## REMARKS

Reconsideration of the present application as amended is requested. In the first Office Action mailed February 13, 2004, specification was objected to for failure to provide the serial number and filing date of the related application referenced on page one of the application. The specification has been so revised and withdrawal of this objection is requested.

FIG. 1

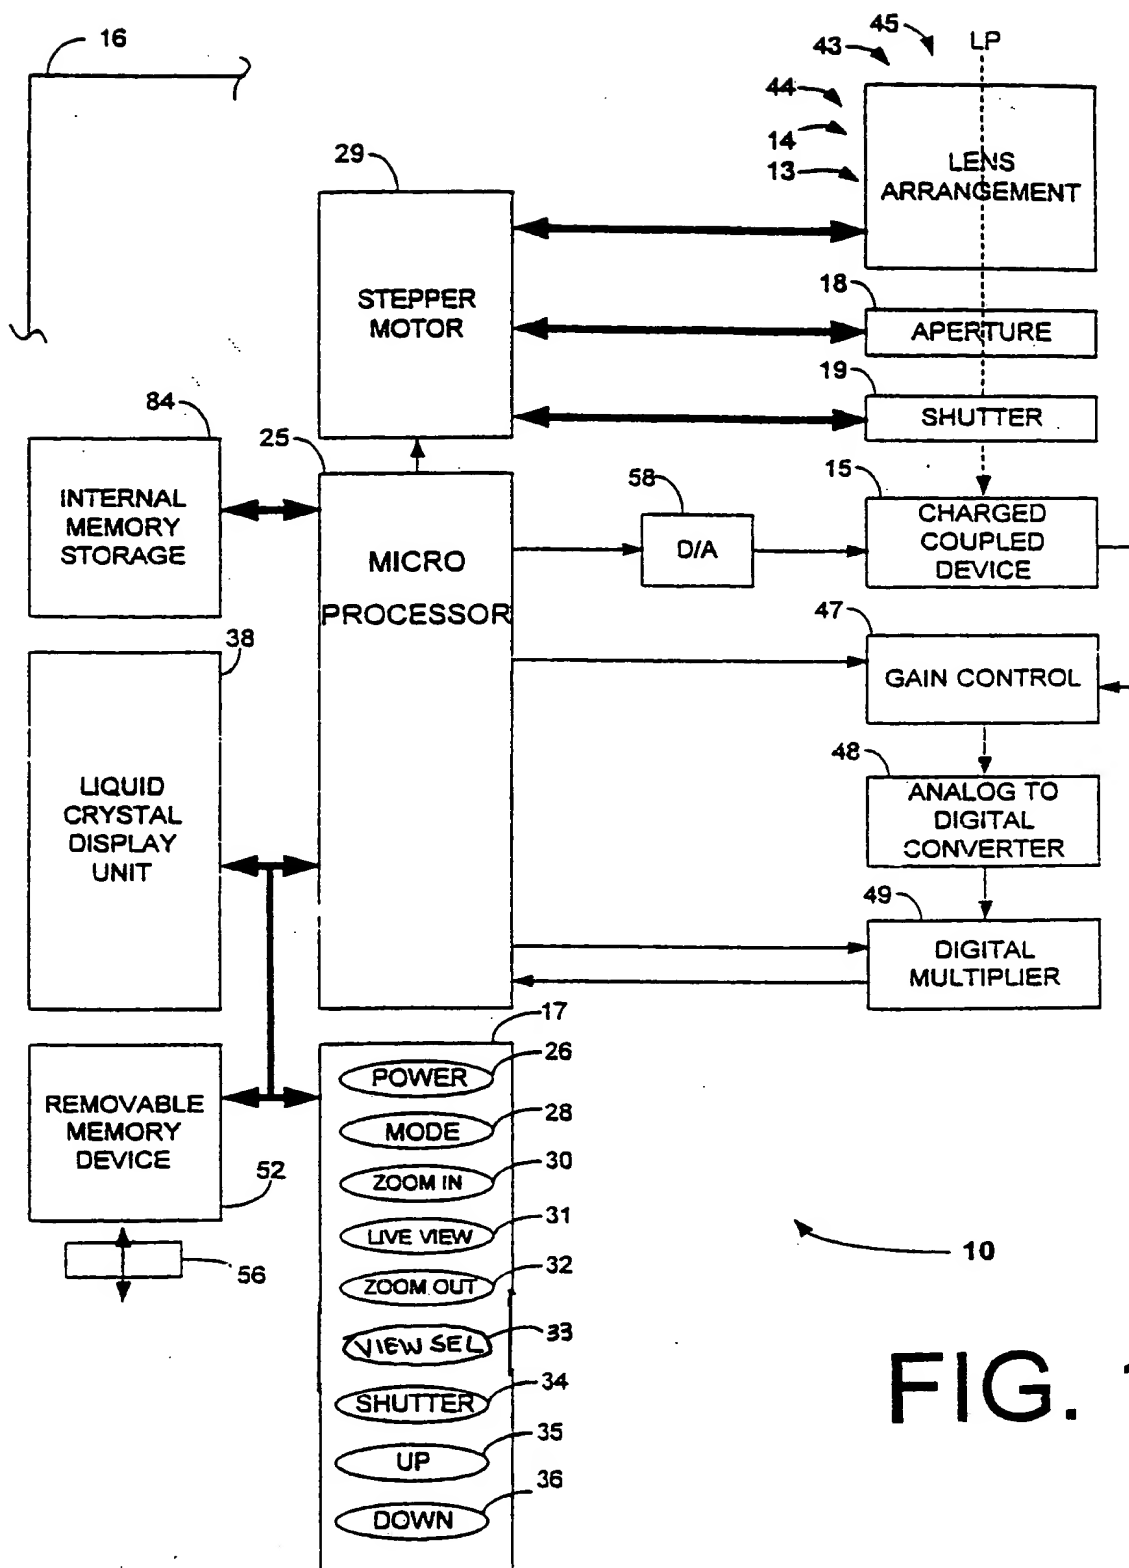
The drawings were objected to by the examiner because Fig. 1 did not include reference numeral 33. A copy of Fig. 1 is transmitted herewith with the proposed drawing correction indicated thereon in red ink. More particularly, Applicant proposes to add an oval with the term VIEW SEL and a reference numeral 33 to illustrate the view select switch 33 described on page 8, line 2 of the specification. No new matter has been added.
